## Application for Works Approval Amendment

<b>Works Approval Number</b>	W6526/2021/1
<b>Works Approval Holder</b>	Murrin Murrin Operations Pty Ltd
<b>ACN</b>	076 717 505
<b>File Number</b>	DER2021/000132-1
<b>Premises</b>	Murrin Murrin North Murrin Murrin Nickel Cobalt Project  Legal description –  Mining tenements M39/342, M39/343, M39/421, M39/424, M39/553  Shire of Leonora and Shire of Laverton  As defined by the coordinates in Schedule 2 of the Revised Works Approval
<b>Date of Report</b>	20 April 2023
<b>Decision</b>	Revised works approval granted

**Figure 1: Proposed pipeline and discharge points to 17 Series In-pit TSF**

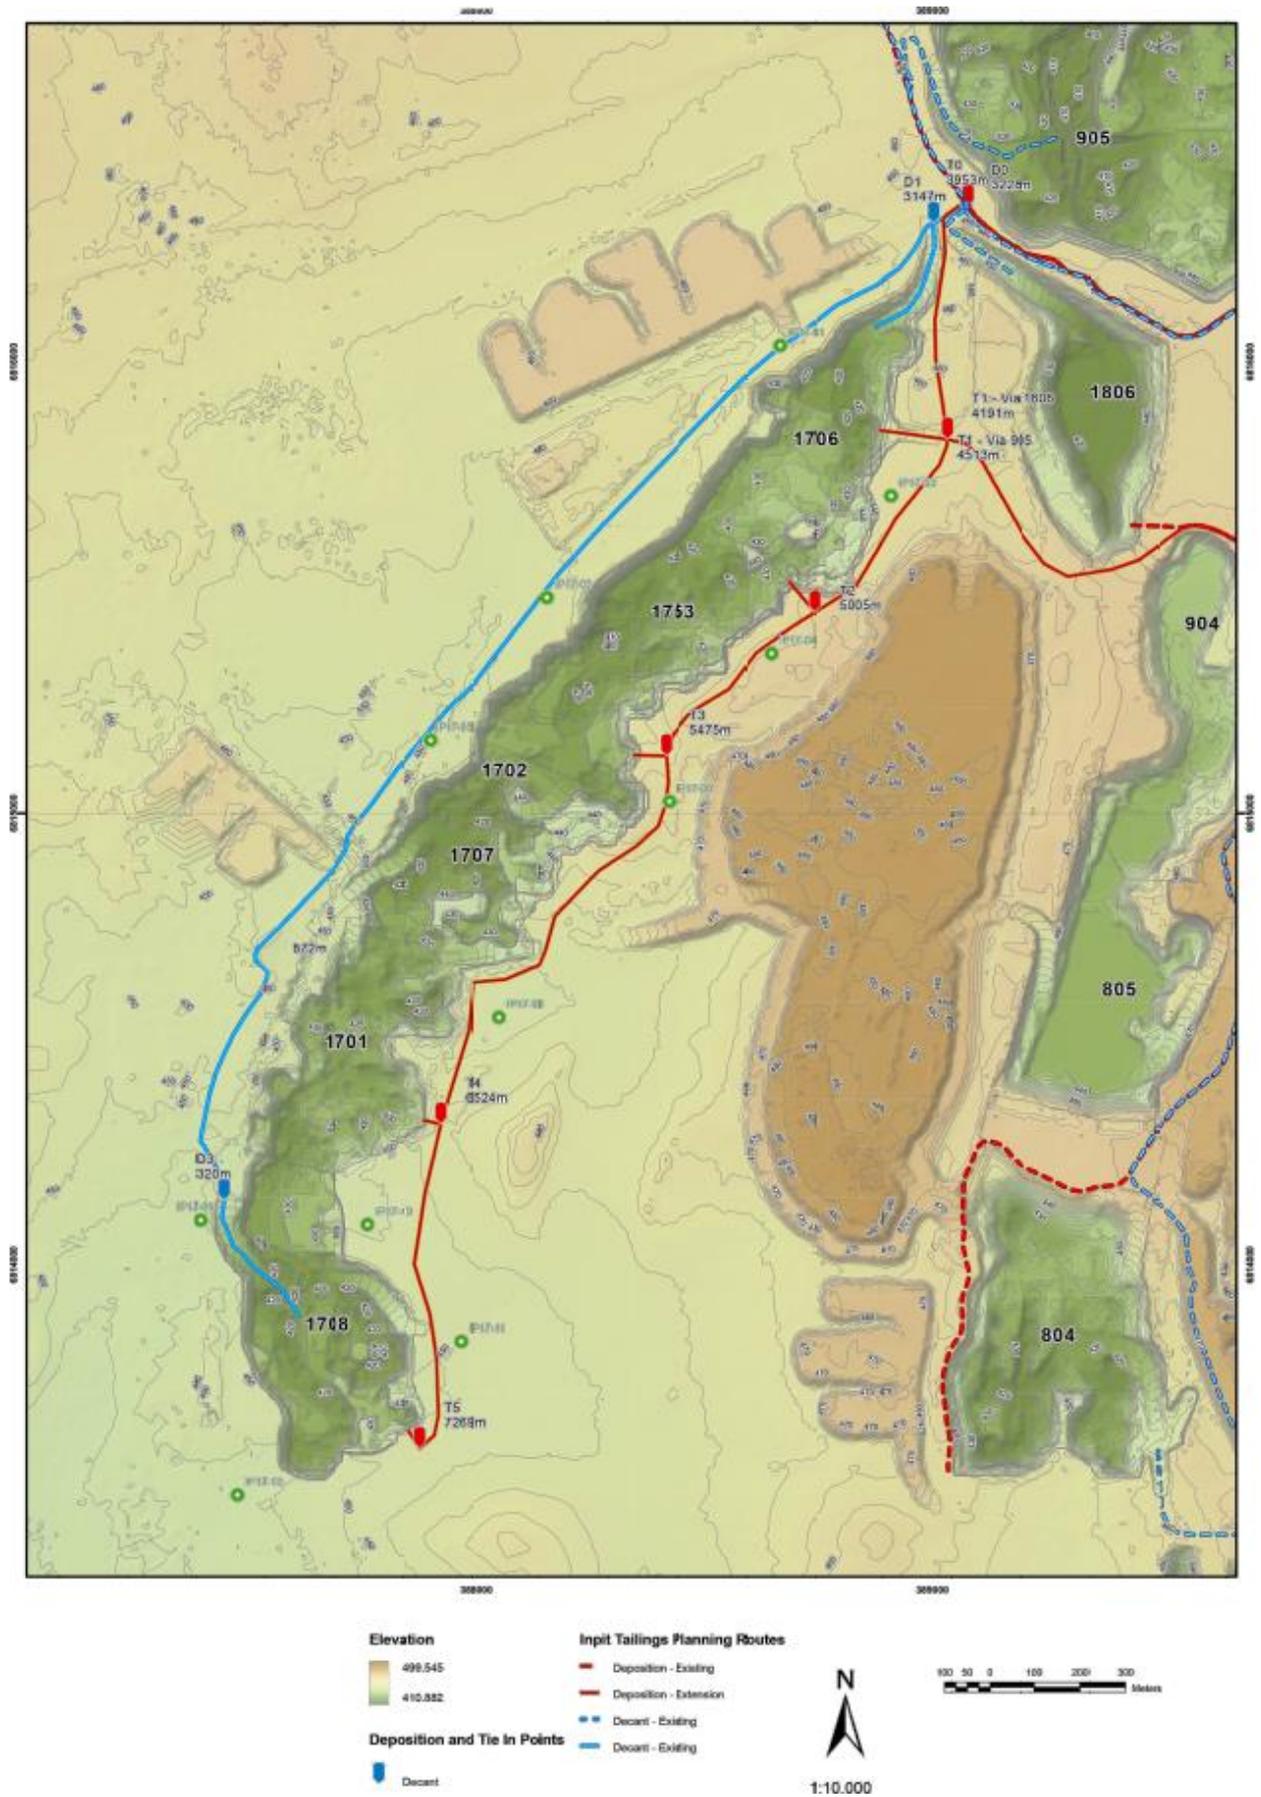
- The Works Approval Holder propose to amend Stage 3 of the Works Approval as the supernatant pond has moved to the southern end of the pit sooner than anticipated.
  - The Works Approval Holder propose to install decant point D3 during Stage 2, and not install decant point D2 as it is no longer required.
  - The construction / installation of the decant pipeline and bunding will be longer to D3 (approximately 3.9 km) than to D2 (3 km).
  - No installation of decant infrastructure to occur during Stage 3
- In addition, the Works Approval Holder propose to install discharge point T0 in Stage 4 to ensure even tailing discharge and beach development.
  - Additional tailings pipeline and bunding of approximately 500 m will be required to the T0 location at northern point of TSF.

There will remain four stages in the life of the in-pit TSF, but Stage 4 will now include the installation of one additional discharge point (as above), whereas previously Stage 4 did not involve any works, only a change to discharge and decant recovery locations.

Condition no.	Proposed amendments
Table 1: Design and construction / installation requirements	Change of decant recovery point at Stage 2 from D2 (3,000 m of pipeline) to D3 (3,900 m of pipeline).  Addition of Stage 4 pipeline and deposition point T0 to the works approval
Table 2: Infrastructure and equipment requirement under time limited operations (TLO)	Changes to infrastructure design and construction requirements to include Stage 4
Figure 4	Update figure to show revised staged tailing deposition and decant water points and pipeline.
Table 5: GW monitoring of ambient concentration	Add in Stage 4 to ambient concentration frequency
